# **IPPC Permit Renewal Variations**

This document provides an overview of the variations that shall be put forward for the upcoming renewal process of IPPC permit IP 0002/07/Gi – ElectroGas Malta Ltd

Figure 1 - Site plan showing current (A) and planned location (B) for make-up water glycol tank. Shaded area represents the main Regas bunded area.

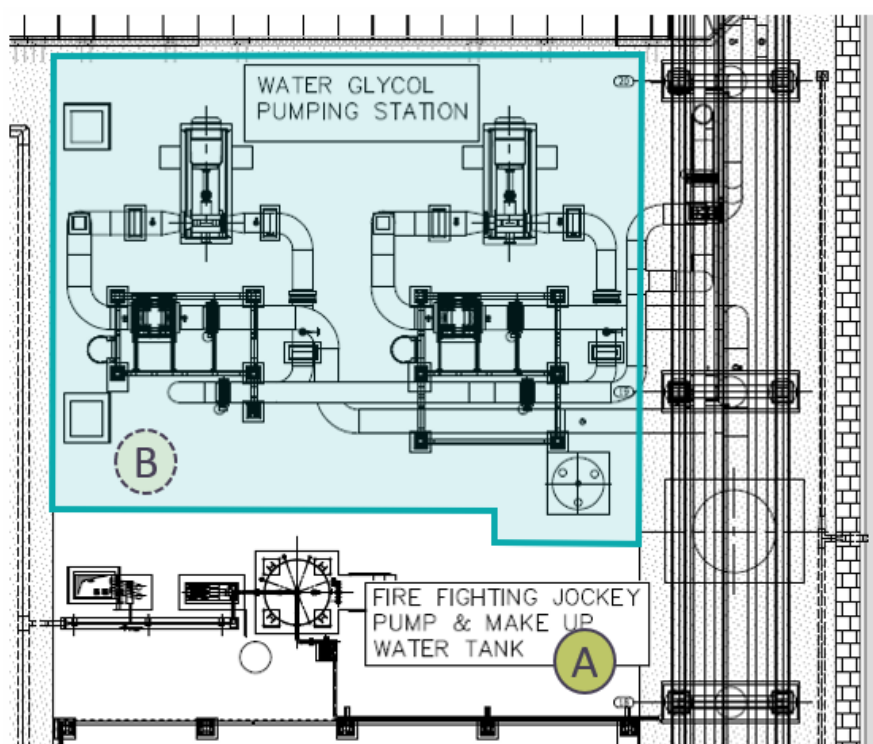
The current make-up water glycol tank was moved to the main bunded area within the Regasification plant, such that the present bunding of this tank is improved. This move will further reduce the risk of groundwater contamination.

*Figure 2 - Oil boom installed on the quay adjacent to the Delimara 4 portacabin offices.*

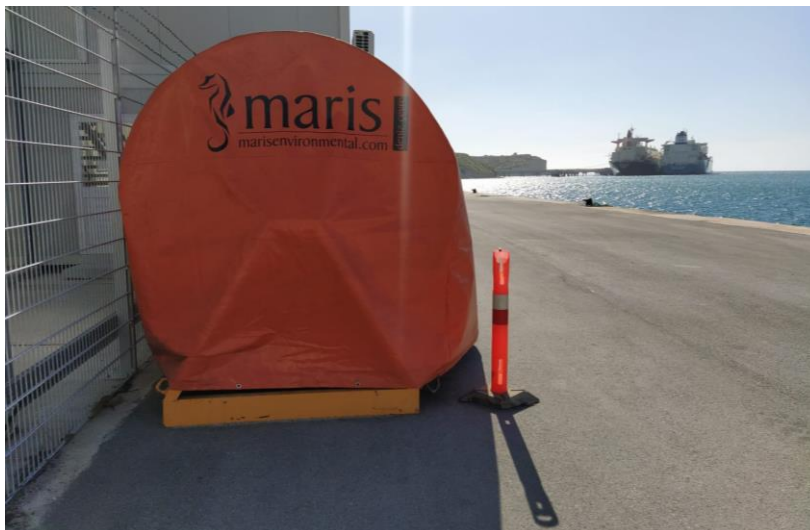
A 300-meter oil boom has been installed on the quay adjacent to the Delimara 4 portacabin offices. This oil boom allows for quick and efficient deployment in case of an oil spill within our sea area.

Figure 6 – As-built plans of the Delimara 4 Portacabin Offices.

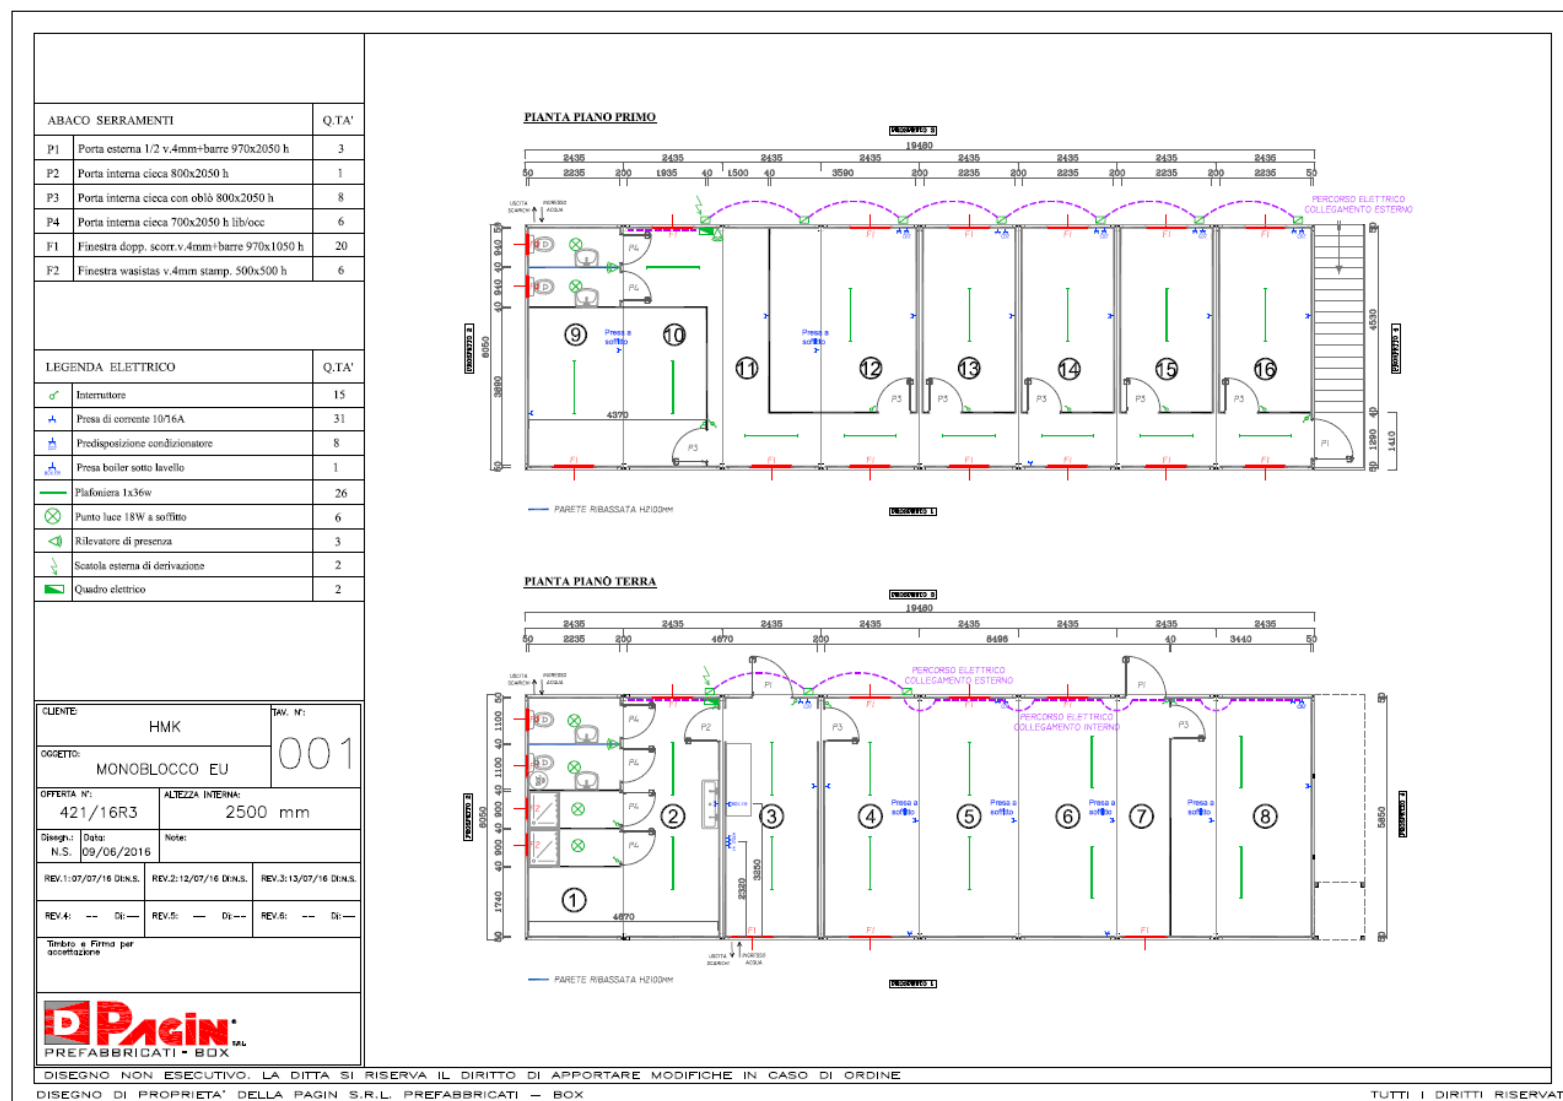
A total of sixteen 20-foot portacabins have been installed in Delimara 4 area to be used as offices. The portacabins have been placed such that a row of 8 units placed adjacent to each, are stacked on top of another row of 8 units. Layouts of the ground floor and the 1<sup>st</sup> floor are shown in Figure 6, whereas Figure 7, shows the location of these portacabins. Planning Authority's decision to grant permission for these offices (PA/04297/18) was posted on 17<sup>th</sup> November 2018, with commencement date being 10<sup>th</sup> December 2018.

Figure 7 - Site plan of Delimara 4 area showing the locations of the Portacabin Offices (yellow) and the Chemical Stores (red & orange).

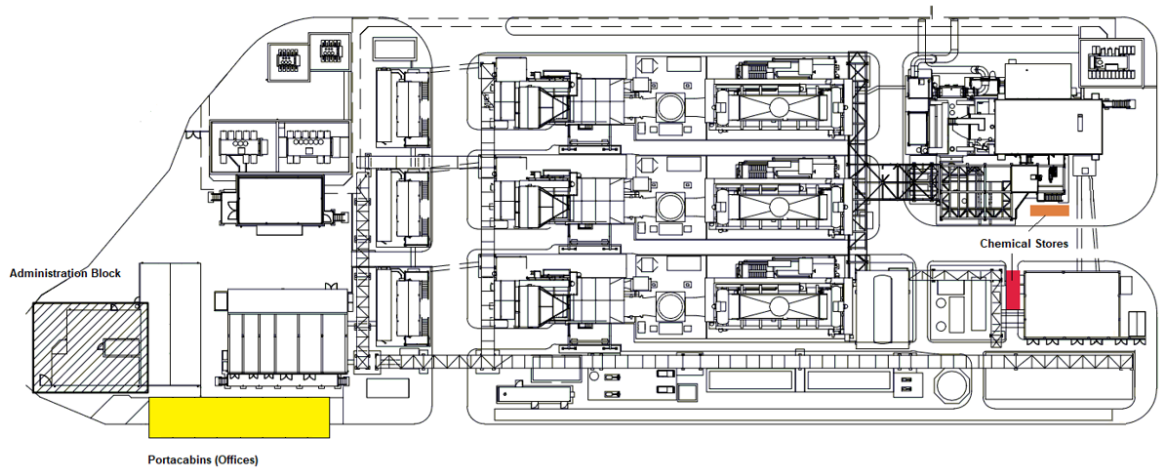
Two 20-foot containers were placed on site as shown in the site plan below, in order to be utilised as chemical stores within the Delimara 4 area.

Figure 9 - Layout showing the portacabin arrangement of Reganosa offices.

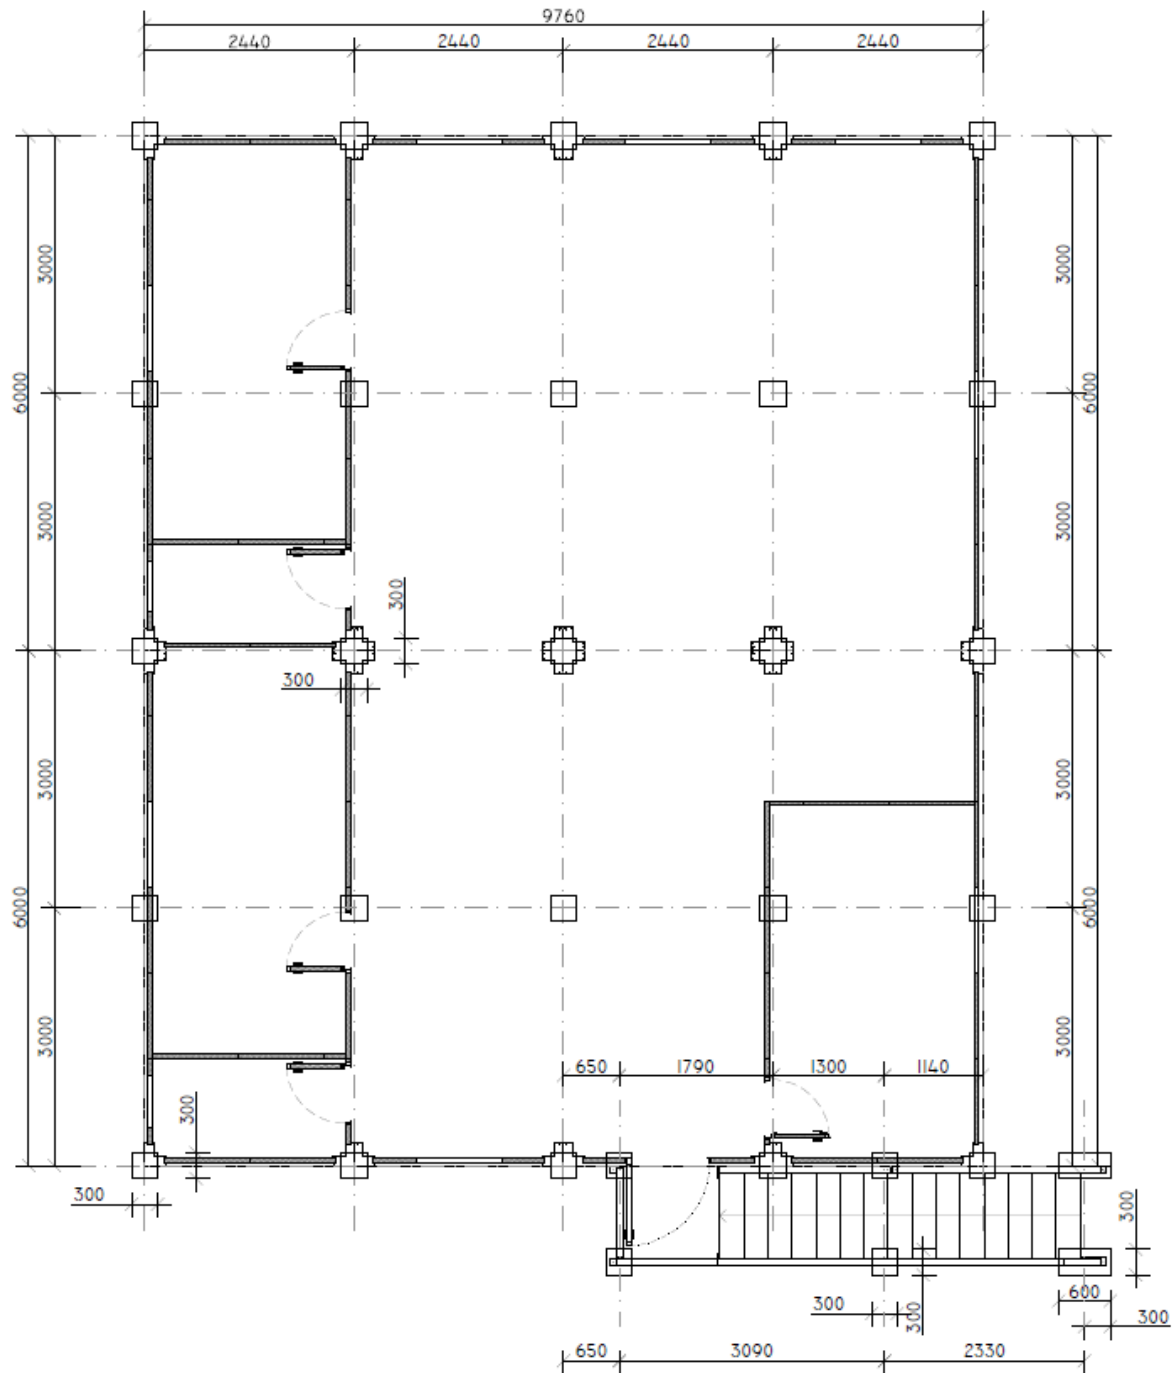
A new modular office building was installed in the Regasification area and is composed of 16 modules distributed over two floors, the arrangement of which is shown in Figure 9. The installation of cabins in the re-gasification area together with storage containers (PA/04118/18), was granted permission by the Planning Authority, with 12<sup>th</sup> November 2018 as the commencement date.
